**8. Usha Chatwani, P.E., Associate Civil Engineer, Community Project Review Unit,
Santa Clara Valley Water District, May 15, 2003**

10. Roy Molseed, Senior Environmental Planner, Santa Clara Valley Transportation Authority (VTA): May 16, 2003

11. Terry Roberts, Director, State Clearinghouse, California Governor's Office of Planning and Research; May 19, 2003

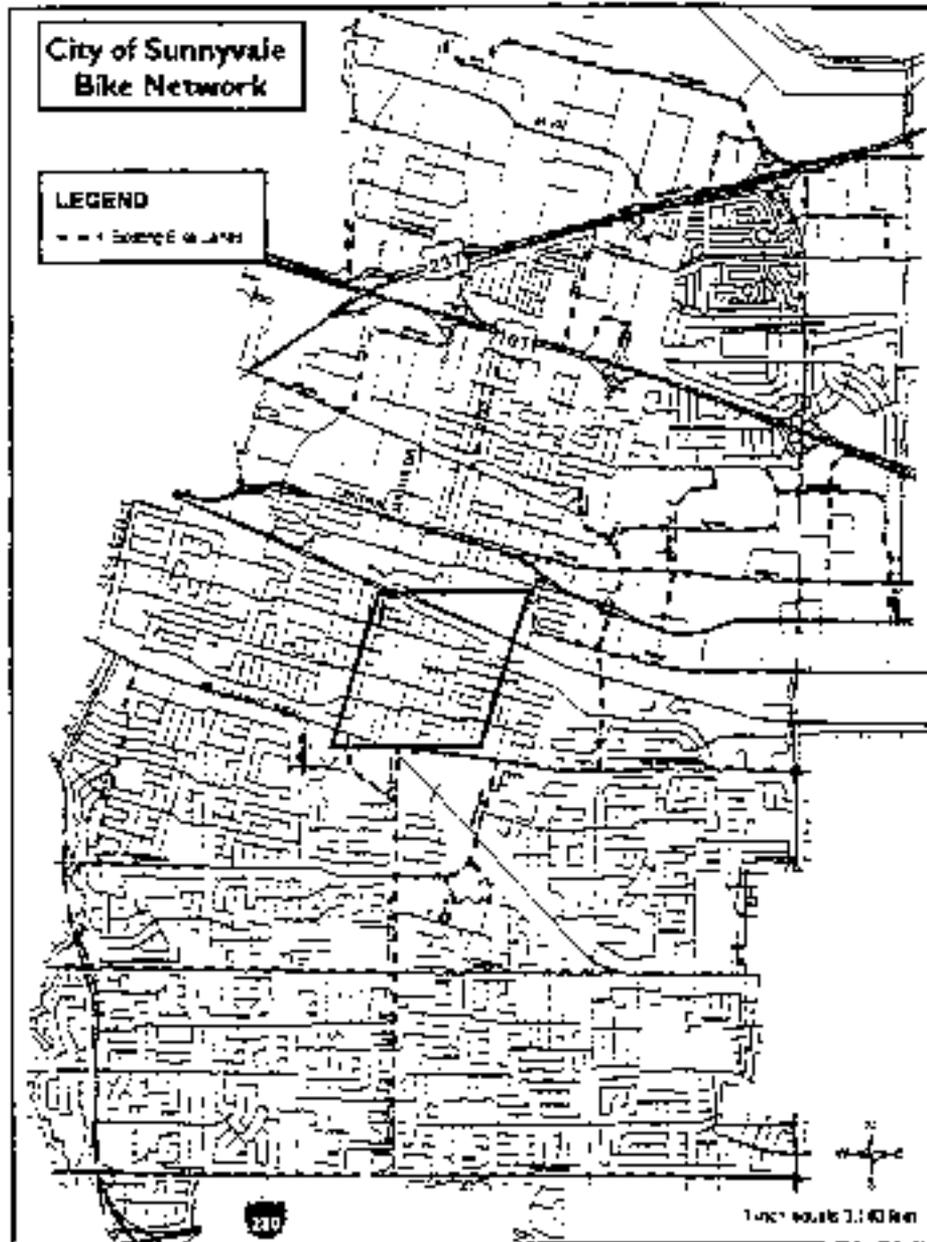
Comment 9.04: Air Quality, Transportation and Parking. Additional mitigation suggestion regarding bicycle connections between downtown Sunnyvale and other local and regional bicycle routes.

Response: A number of bikeways are in place or planned to connect downtown Sunnyvale and local/regional bikeways. The map below illustrates the current bikeway network in Sunnyvale relative to the downtown:

The City has a long range Bicycle Capital Improvement Program that identifies potential improvements for bicycles to all arterial and collector streets. This document will assist the City in building out additional bikeway network connections.

Sunnyvale Downtown Improvement Bus Stops In Project

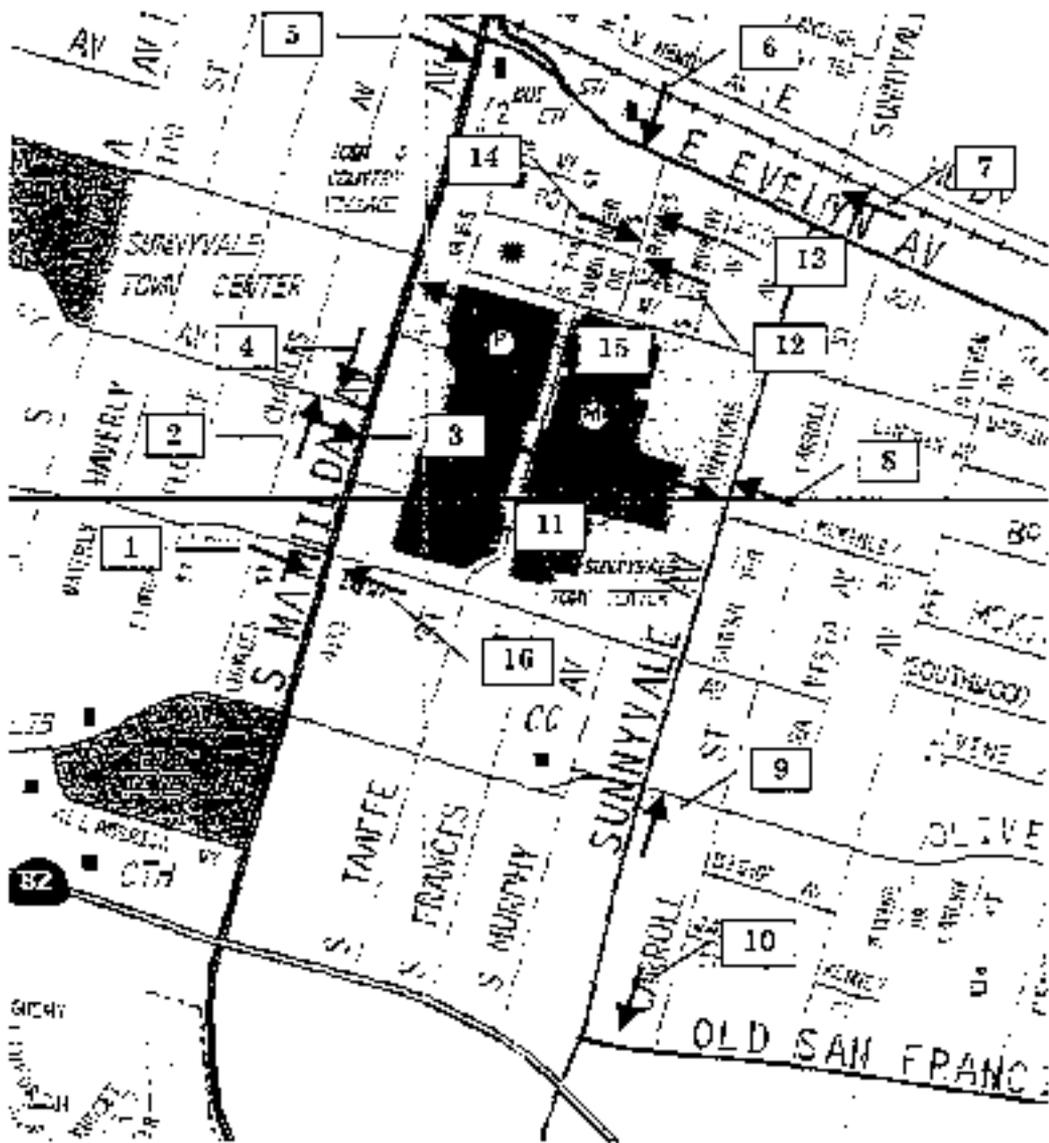
The role of the bus is an important transit option in downtown Sunnyvale. The Downtown Design Plan presents an opportunity to include specific plans for bus stop improvements. Specifically, bus stop improvements along Machado Avenue should be included as an element of the urban design plan. The underlying goals of bus stop improvements include enhancing the street character, improving connections, creating interesting public spaces, and increasing a sense of awareness and identity for transit services.

Comment 10.02: Transportation and Parking. "[B]us stop improvements along Matilda Avenue should be included as an element of the urban design plan."

Response: The commenter is not specific about the type of bus stop improvements. Bus stop improvements such as signs, benches, and shelters would be accommodated by the proposed project (update), and it is assumed that these would be provided as part of the transit provider's program to furnish these amenities. The current Downtown Specific Plan requires specialized streetscape features including enhanced paving, decorative lighting fixtures, large canopy trees on major streets, tree grates, and other street furniture such as benches, trash cans, etc. These streetscape requirements will be retained and/or updated in an amended Downtown Specific Plan.
